Amendments to the Drawings:

Annotated Sheets Showing Changes

FIG. 7

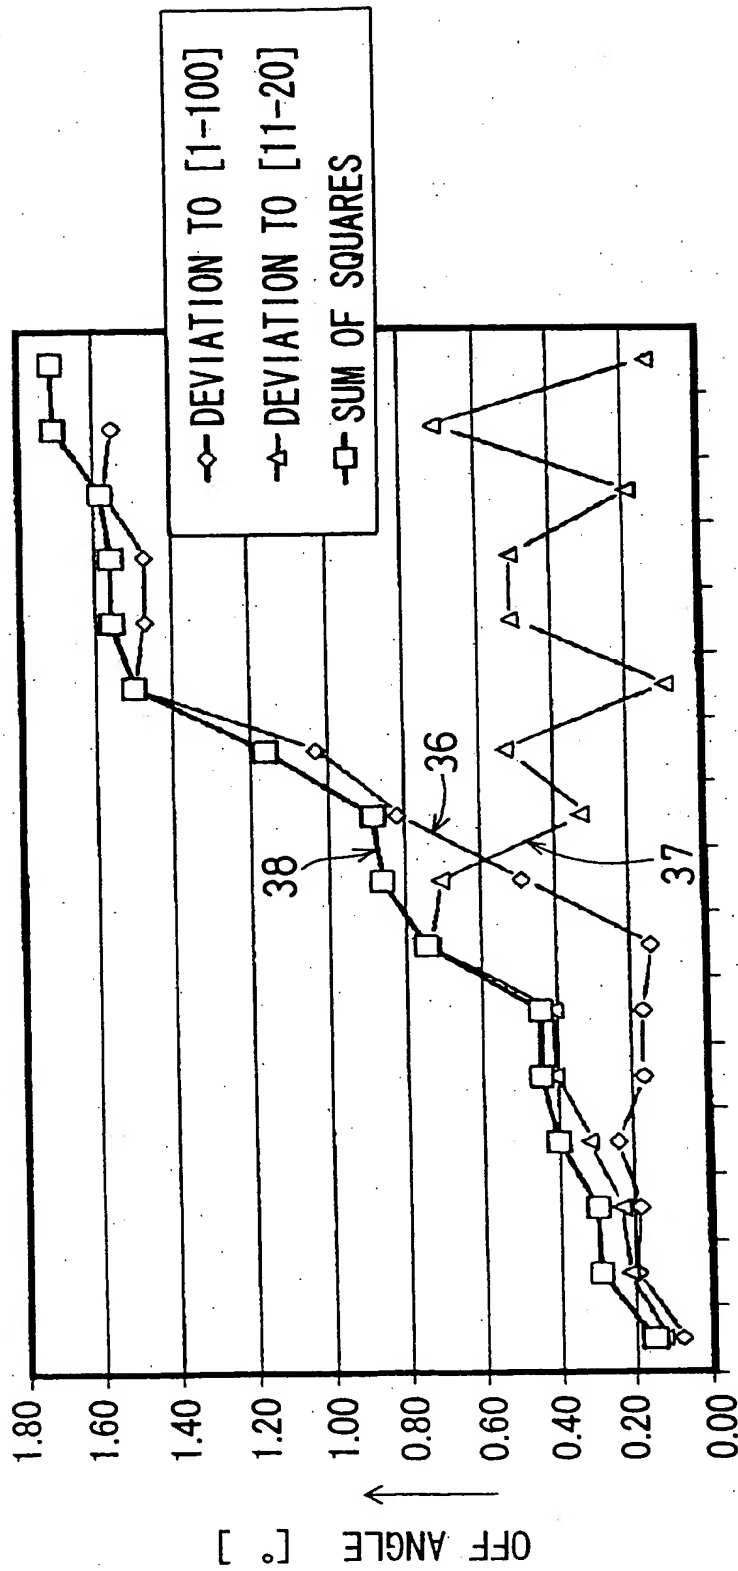
SUBSTRATE
OFF ANGLE BETWEEN NORMAL LINE ON SURFACE OF ZrB_2 BOARD-
AND [0001] AXIS, AND SURFACE MORPHOLOGY

SURFACE MORPHOLOGY

FIG. 10

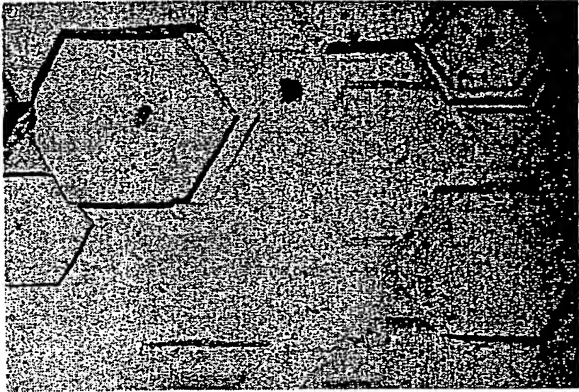
1100°C OR MORE 0.25 873 ~~SECONDS~~
ARCSECONDS 400°C 0.8 —

725°C 0.6 760 ~~SECONDS~~
ARCSECONDS

850°C 0.5 596 ~~SECONDS~~
ARCSECONDS

FIG. 12

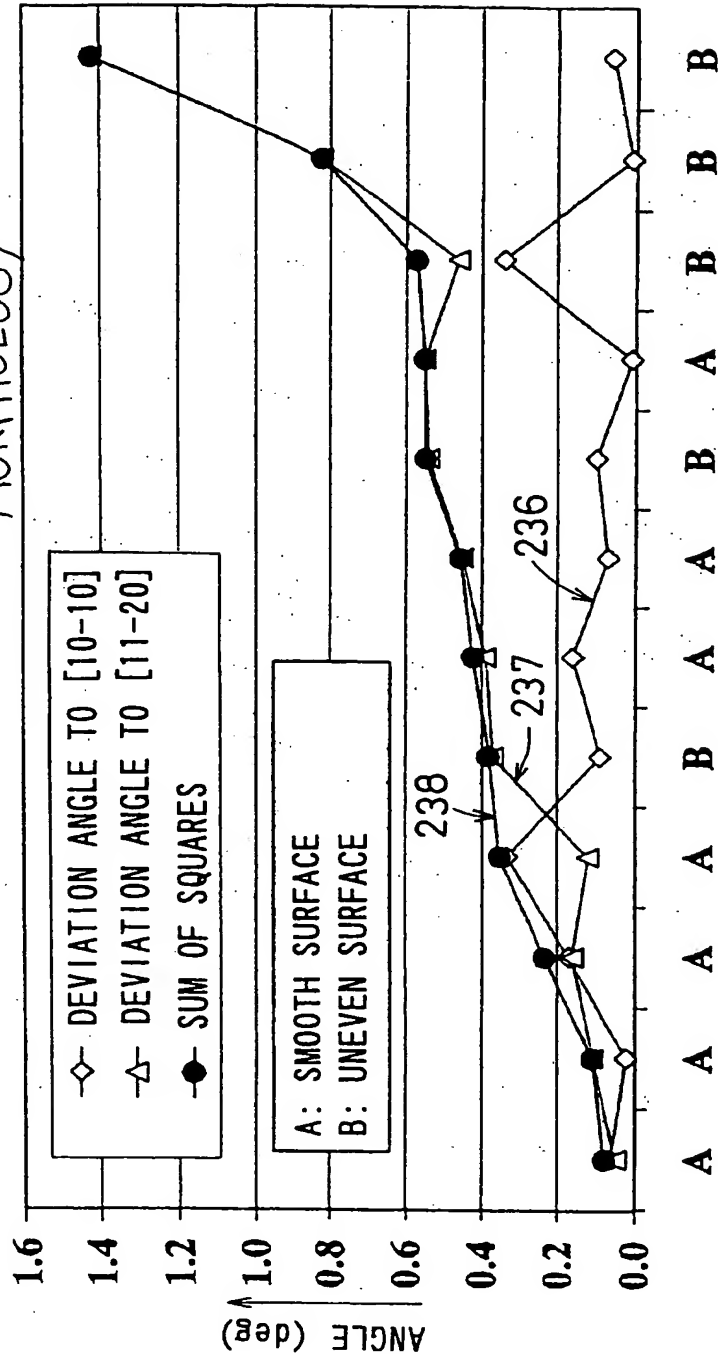
RELATION BETWEEN OFF ANGLE OF NORMAL LINE OF SURFACE OF ZrB_2 BOARD-
FROM [0001] CRYSTAL AXIS AND SURFACE STATE OF GaN EPITAXY FILM
MORPHOLOGY

SURFACE STATE OF GaN EPITAXY FILM
MORPHOLOGY
